SUBJECT: **Conditional Use Permit, Site Plan Review, Adjustment Driveway Approach Permit and Design Review Case No. CU-SPR-DAP-DR21-05 – 4900 Block of State Street – 97301; Supplemental Staff Report**

On January 24, 2022, the applicant submitted an updated site plan (Sheet SDR3) and building elevation plans (**Attachment A**). On January 26, 2022 the applicant submitted an updated written response. The following is a staff response to the applicant's updated plans and findings (**Attachment B**).

EAST PARK APARTMENTS

EAST ELEVATION (TYPE E UNITS)
 SCALE: 1/8" = 1'-0"
 BLD. 21. 24+26

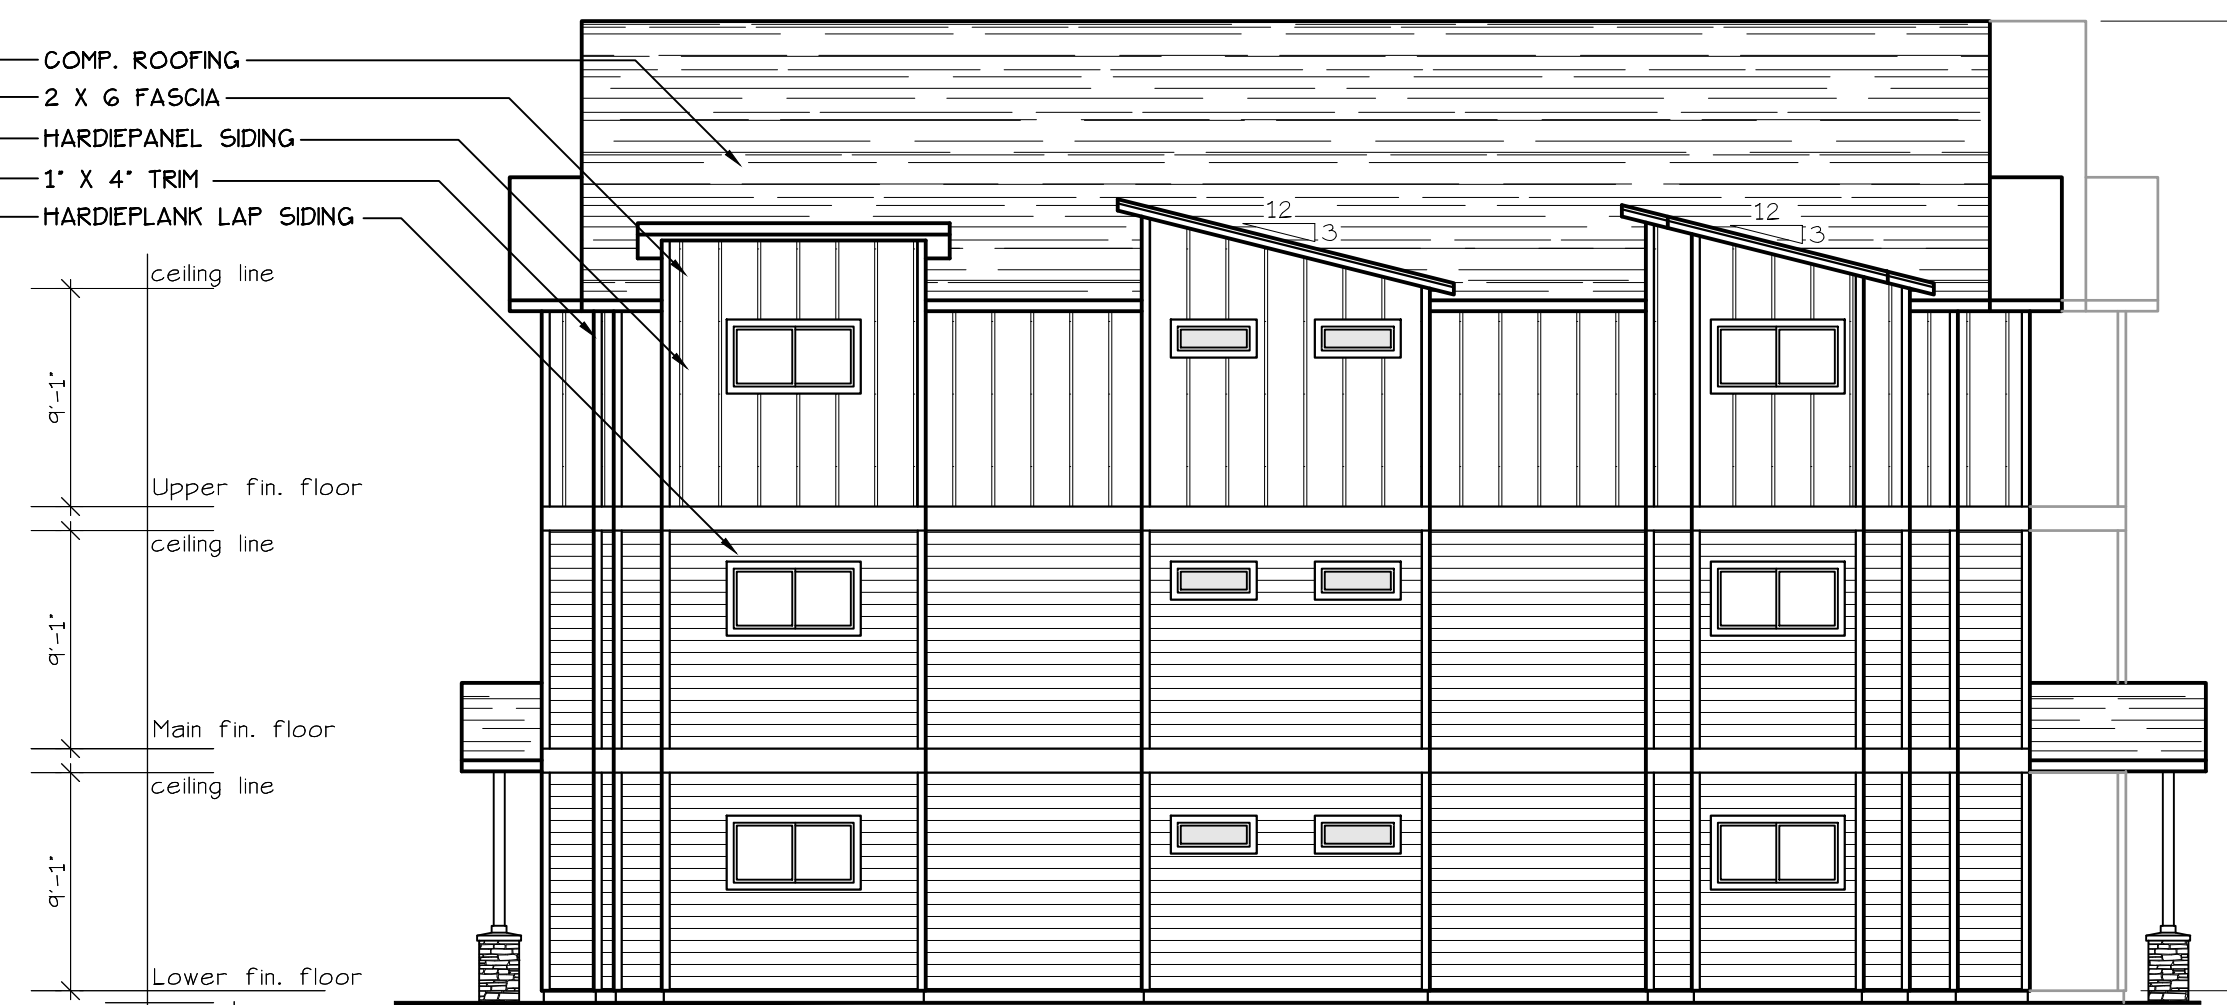
- d. Additional window area.

The building plans and elevations provided for the December 22, 2021 hearing showed that windows were not provided in habitable rooms at the end elevations for proposed buildings 1-8, 10, 14-20, 22, 25 and 27 which is not in compliance with the multi-family design standards for site safety and security. The applicant's update building plans identify additional windows provided in habitable rooms in compliance with the multi-family design standards, staff has no further concerns.

This provision requires windows on each wall in habitable rooms that face common open space, parking areas, and pedestrian paths. Previously, the habitable rooms at the end elevations for Buildings 1-8, 10, 14-20, 22, 25, and 27 did not include windows. The revised elevations are enclosed, and demonstrate this standard is met.
